RESPONSE TO REQUEST FOR ADDITIONAL INFORMATION

APR1400 Design Certification

Docket No. 52-046

RAI No.: 291-8347
SRP Section: 04.05.02 – Reactor Internal and Core Support Structure Materials
Application Section: 4.5.2
Date of RAI Issue: 11/04/2015

Table 3 RVI Assembly Diagram

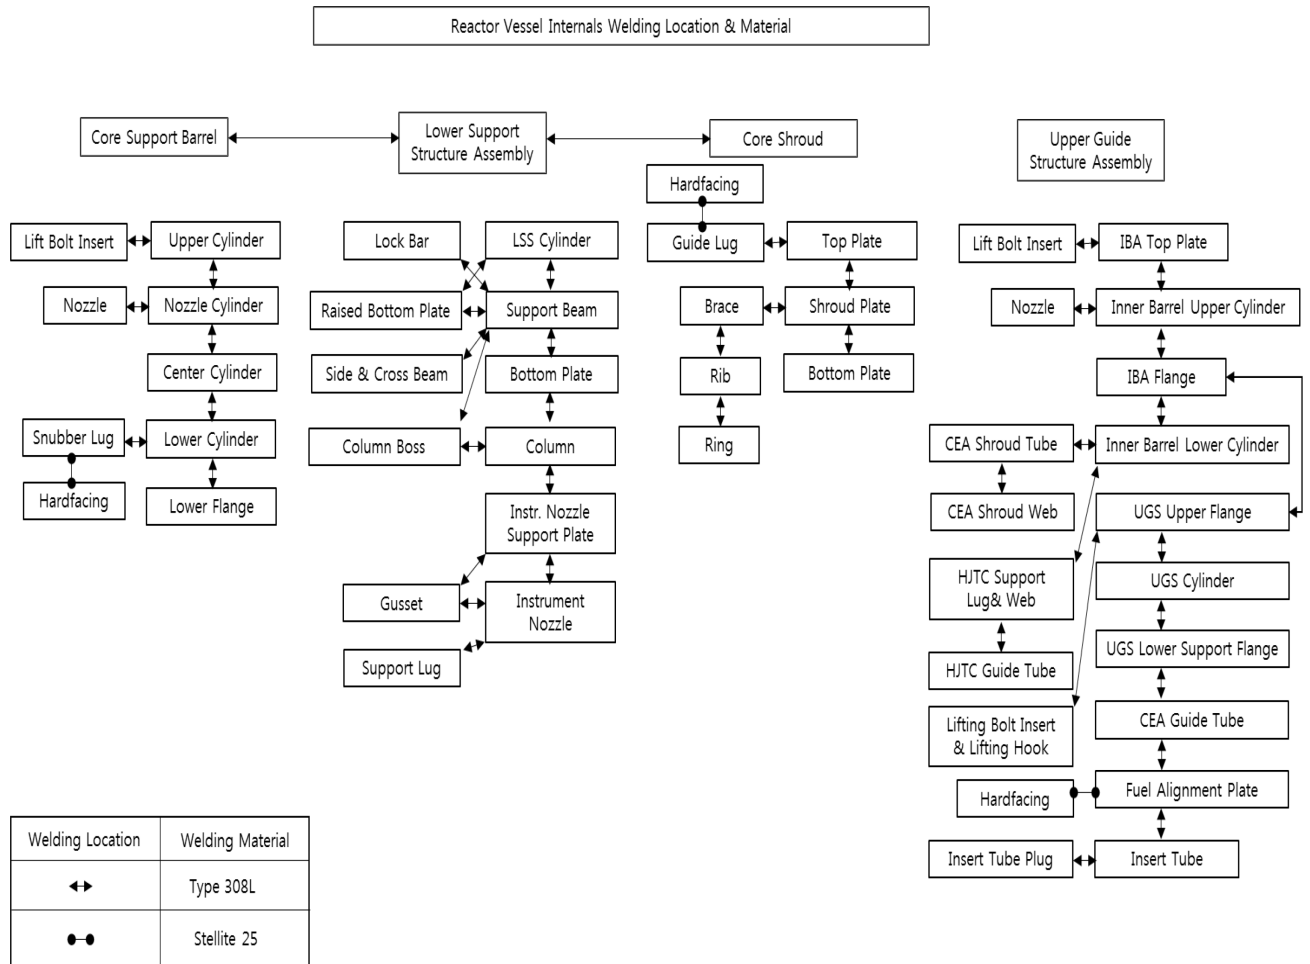
In addition, the staff requests that the applicant provide accompanying assembly diagrams for all components in the table specifying where welds are located and of what material they will be made.

In addition, an assembly diagram identifying weld materials is provided with the following Table 3 for staff’s review.
